AMENDMENT TO FACILITY OPERATING LICENSE

Amendment No. 10  
License No. DPR-62

SAFETY EVALUATION BY THE OFFICE OF NUCLEAR REACTOR REGULATION  
SUPPORTING AMENDMENT NO. 16 TO FACILITY OPERATING LICENSE NO. DPR-62

BRUNSWICK STEAM ELECTRIC PLANT UNIT 2

Figure 1. Plug Installed in Core Plate

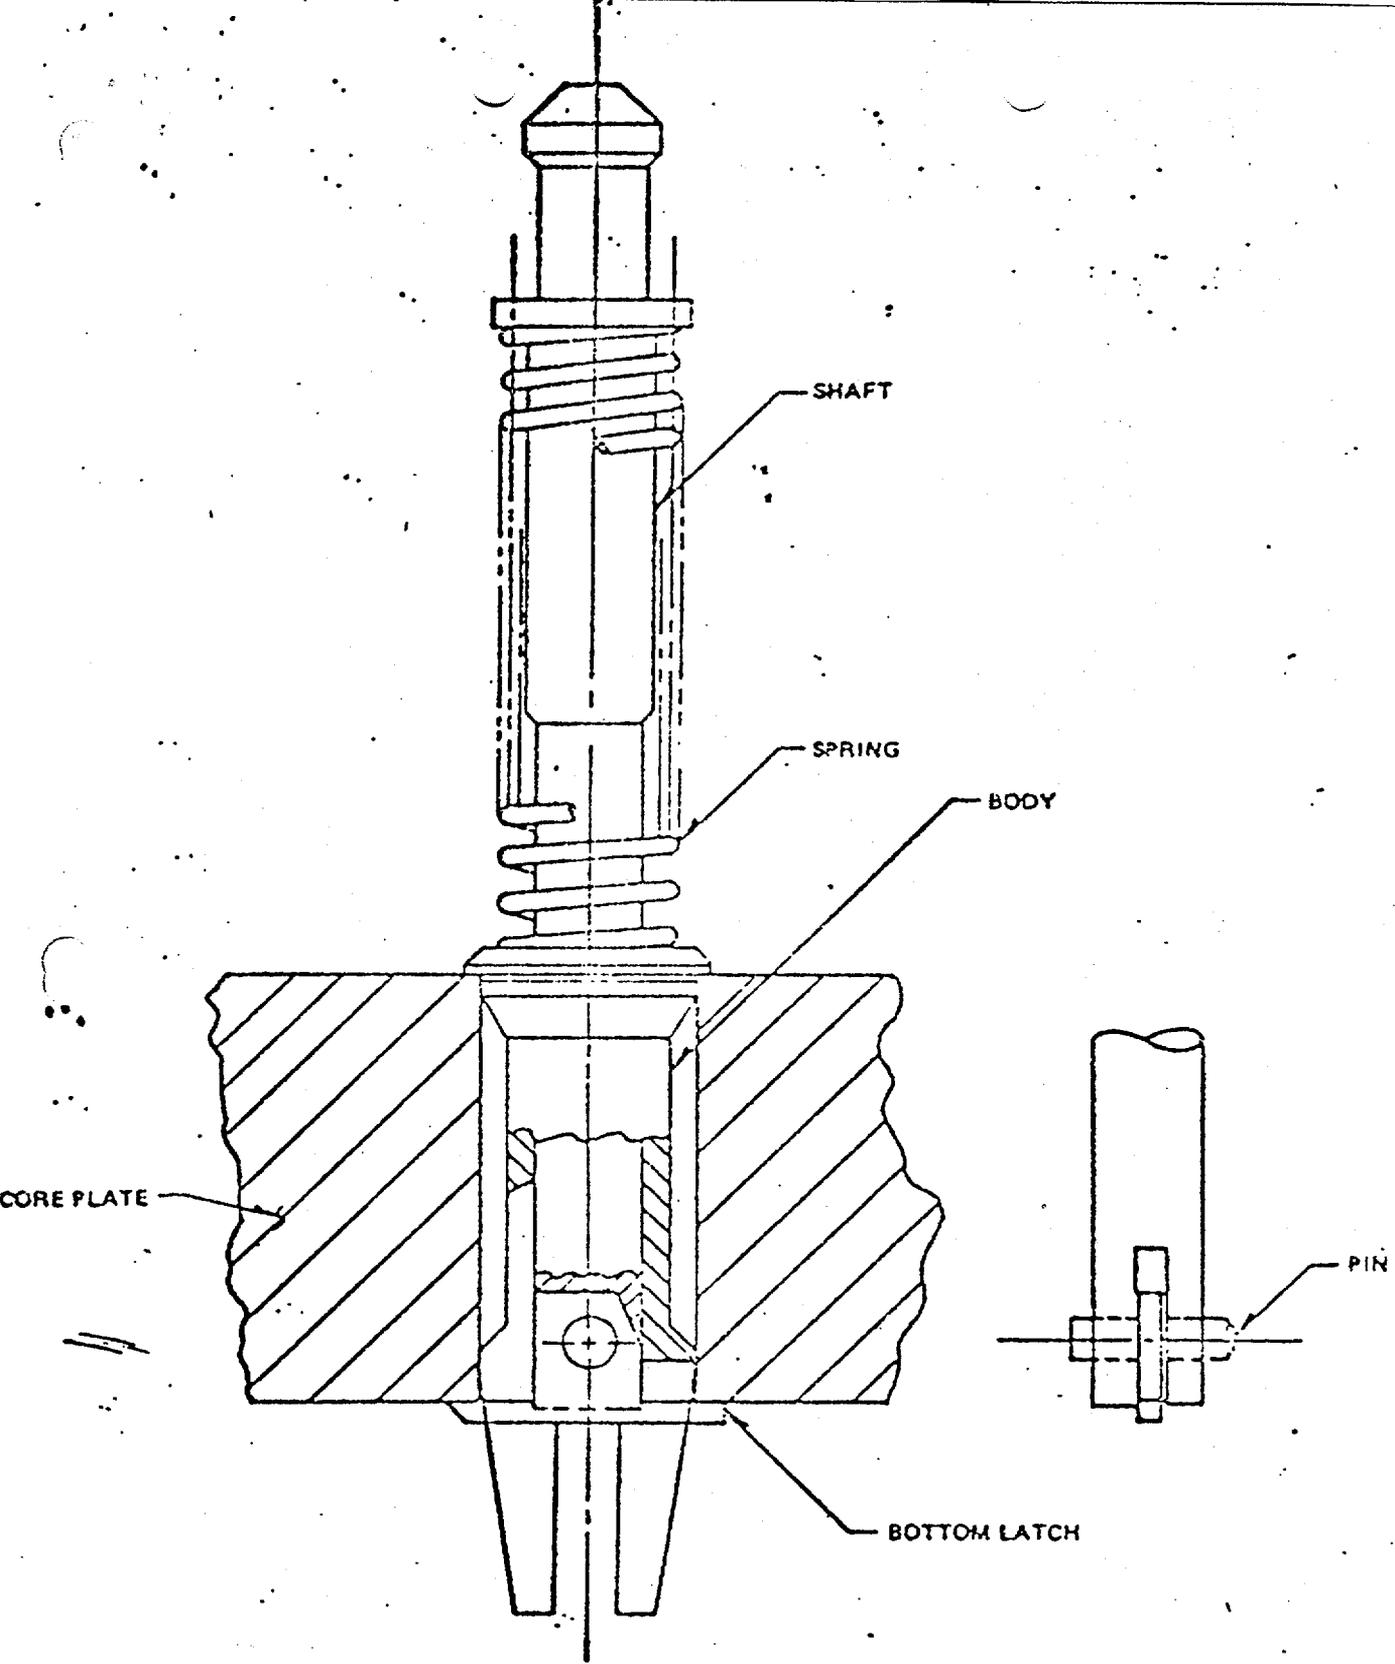
The plug consists of five basic parts, as shown in Figure 1. Identical plugs have previously been installed at Vermont Yankee, Pilgrim, Cooper, Hatch and Duane Arnold. The body provides a means of guiding the device into the bypass flow holes as well as a shoulder to support the plug and form a seal against water flow. The shaft extends through the body. A knob is provided at the top of the shaft to provide a means of grabbing the plug during installation and extraction. At the bottom, the latch is attached to the shaft by a pin. The latch is free to rotate during installation. The spring acts against the body and shaft during normal operation to provide the force necessary to offset the pressure differential acting on the body.

During installation, the plug has its latch rotated 90 degrees from its installed position and is withdrawn and locked in the body. The shaft is gripped by the installation tool, and the plug is inserted into the bypass flow holes. The body engages the rim of the hole. The shaft is pushed to its full extension, thus lowering and unlocking the latch below the underside of the core plate. The latch then rotates 90 degrees and bears on the bottom of the core plate. After insertion, the plug is pulled with about 30-pound force to test the placement.

The plug can be removed by gripping the top of the shaft with an extracting tool and applying a force of about 500 pounds. The latch's legs will be plastically deformed and the entire plug withdrawn. The plugs previously installed at Vermont Yankee were removed with no abnormalities or loose pieces reported. The force required for removal varied from 500 to 1300 pounds.

Based on a review of the design, the installation methods, and the previously successful operating experience at Vermont Yankee, Pilgrim, Hatch, and Duane Arnold, we conclude that the plugs can be installed without damage to core components, that they will not fail so as to result in loose parts in the core or result in unplugging of the bypass flow holes, and that they can be removed, if necessary, without damage to core components. Thus, the modification is reversible.

Accordingly, we conclude that the installation of the plugs is acceptable. Operation with plugged bypass holes is still under review and will be the subject of a separate licensing action.
